UNITED STATES
DEPARTMENT OF THE INTERIOR
BUREAU OF LAND MANAGEMENT

FORM APPROVED
OMB NO. 1004-0137
Expires: January 31, 2018**SUNDRY NOTICES AND REPORTS ON WELLS**
*Do not use this form for proposals to drill or to re-enter an abandoned well. Use form 3160-3 (APD) for such proposals.*5. Lease Serial No.
NMLC028731B

7. If Unit or CA/Agreement, Name and/or No.
NMNM111789X8. Well Name and No.
DODD FEDERAL UNIT 279. API Well No.
30-015-02978-00-S110. Field and Pool or Exploratory Area
DODD-GLORIETA-UPPER YESO11. County or Parish, State
EDDY COUNTY, NM**SUBMIT IN TRIPLICATE - Other instructions on page 2**

Permanent Abandonment of Federal Wells
Conditions of Approval (LPC Habitat)

Dodd Federal Unit #27 WIW

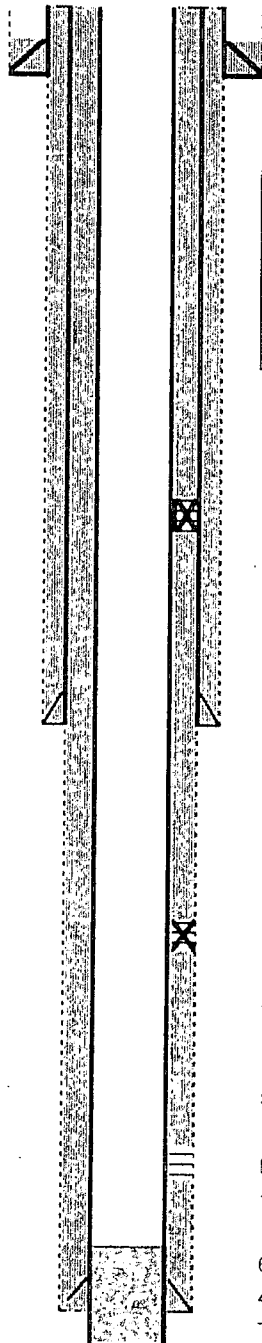
Toc ?

459-84=375' estimated (calculated) top of cement.

T/salt 458
B/salt 835

GB 2192

SA 2560

GL 4000

Yes? 4061

Dodd Federal Unit #27 WIW

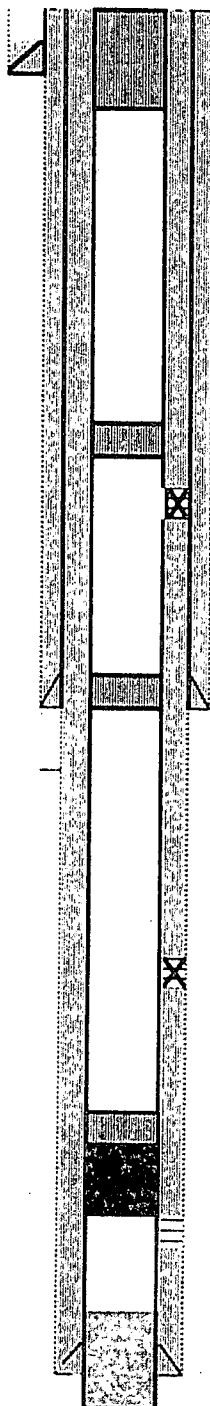
4. Spot 35 sx cmt @ 510' to surface.

3. Spot 25 sx cmt @ 1000-650'. WOC & Tag (B/Salt)

2. Spot 25 sx cmt @ 2346-2000'. WOC & Tag (7" Shoe &

1. Set 4 1/2" CIBP @ 4025'. Circ hole w/ MLF.

Pressure test csg. Spot 25 sx class C cmt @ 4025-3675'
